REPAIR AND CURING OF CONCRETE
REPAIR FOR PLACEMENT 499S02-10B

WATERFORD SES UNIT NO.3
CONTRACT NO. W3-NY-4

SPECIAL PROCESS PROCEDURE		PROCEDURE NO. W-SP-7
TITLE: REPAIR AND CURING OF CONCRETE REPAIR FOR PLACEMENT 499S02-10B		REV. NO. 5 & DATE 8/26/76
PROJECT TITLE: WATERFORD SES UNIT NO. 3 CONTRACT NO. W3-NY-4		
<p>1.0 <u>PURPOSE</u></p> <p>To outline methods used by J. A. Jones Construction Company and Subcontractors for repair and curing of concrete repair for Placement 499S02-10B.</p>		
<p>2.0 <u>SCOPE</u></p> <p>This procedure includes the requirements to be used by J. A. Jones Construction Company and their Subcontractors in the concrete repair of Placement 499S02-10B.</p>		
R-2	<p>3.0 <u>REPAIR SEQUENCE</u></p>	
R-4	<p>3.1 The repair work shall be as follows and performed in the sequence as directed by the Engineer.</p>	
R-1	<p>3.1.1 Epoxy Pressure Grouting Cored Holes with Cracks.</p>	
	<p>3.1.2 Filling of holes not in crack area.</p>	
R-1	<p>3.1.3 Pressure grouting voids and horizontal cored hole #25 in West face.</p>

SK CH-163 REV. 1

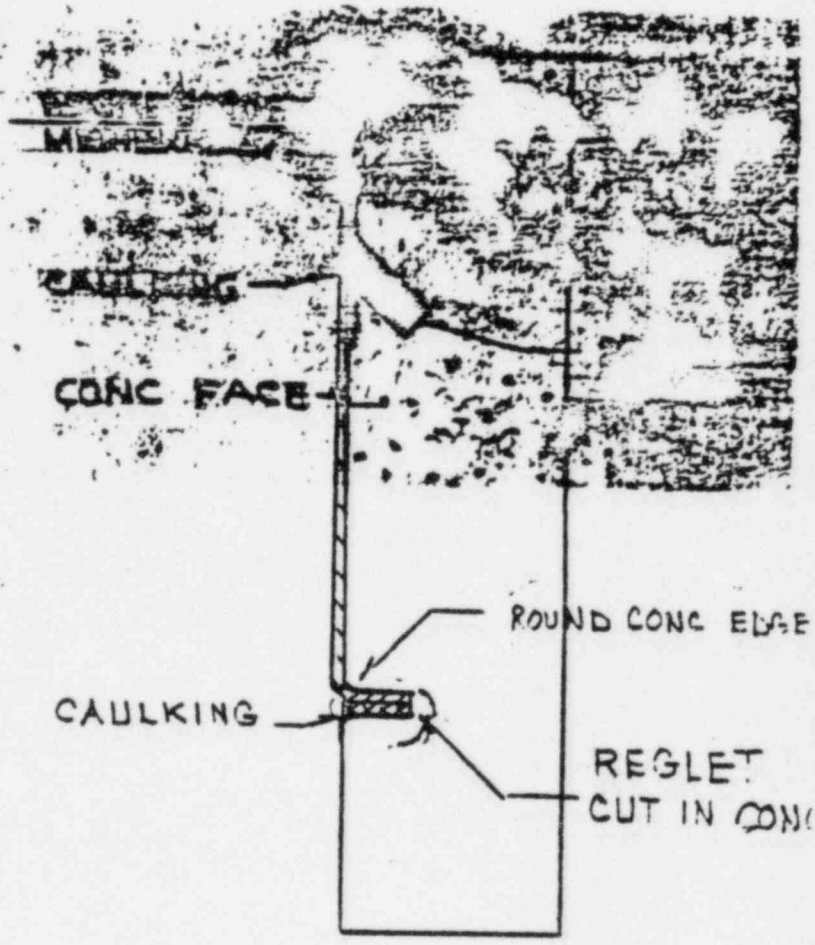
Attached is a revised sketch (SK CH-153, Rev. 1) detailing the extent of waterproofing required on the west face of foundation block 10B. Note that the waterproofing should extend below the effected area or to the top of the pleistocene whichever is lower. For ease of construction the reglet is to be cut horizontally into the concrete.

NOTE: ADD AN ADDITIONAL 12" OF BITUTHENE WITH A BEAD AROUND ALL EDGES AND PIPES.

SECT B-B
WATERPROOFING DET FOR
WEST FACE OF BLOCK 10B

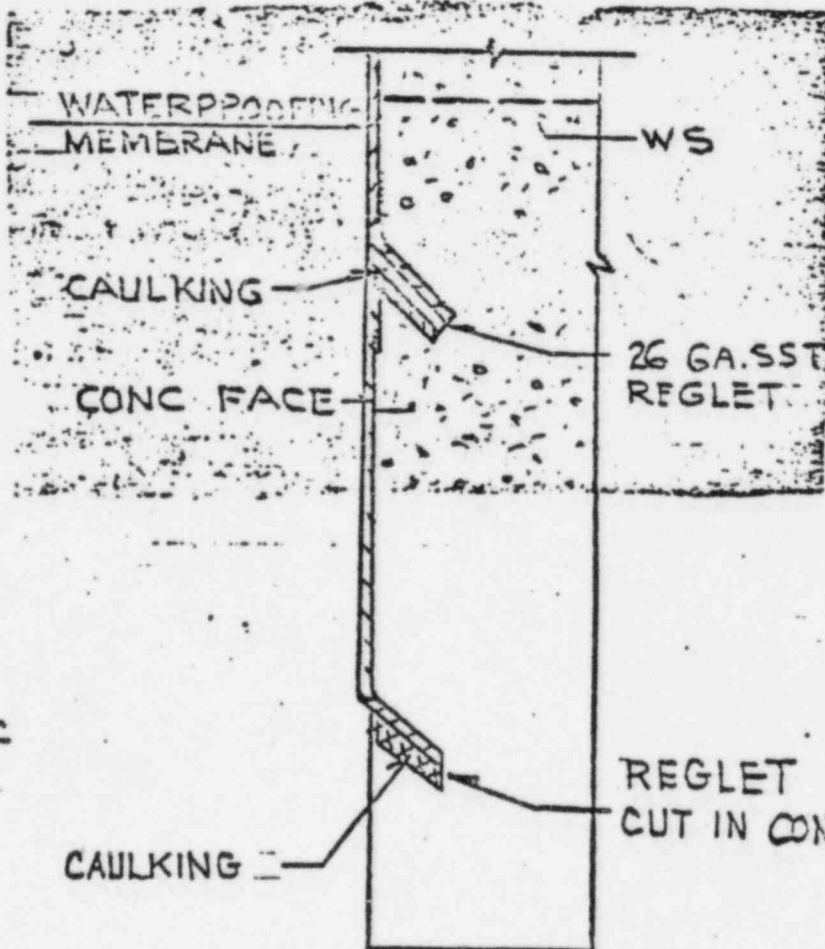
The repair procedure for mat placement 10B, section 9.6, deals with waterproofing the repaired area. The extent of the waterproofing should be such that the entire length of the west face of placement 10B be waterproofed using W. R. Grace's bituthene to a depth as shown on the attached sketch. This will require excavating a trench along the side of the foundation mat, preparing the surface and applying the waterproofing membrane according to Ebasco specification LOU-1564.475. An additional 12 inches of the waterproofing membrane with a bead of bituthene mastic should be installed around all edges.

It should be also made clear that the repair of the voids on the west face of placement 10B be made prior to concreting wall placements 565-1A, 499S04-4A-1 and 499S04-8A-1. These walls are exterior walls located above the voids. The concrete being used to repair these voids should also be allowed to reach design strength before these walls are placed.

NOTE: ADD AN ADDITIONAL 12" OF
BITUTHENE WITH A BEAD OF MASTIC
AROUND ALL EDGES AND PIPES.
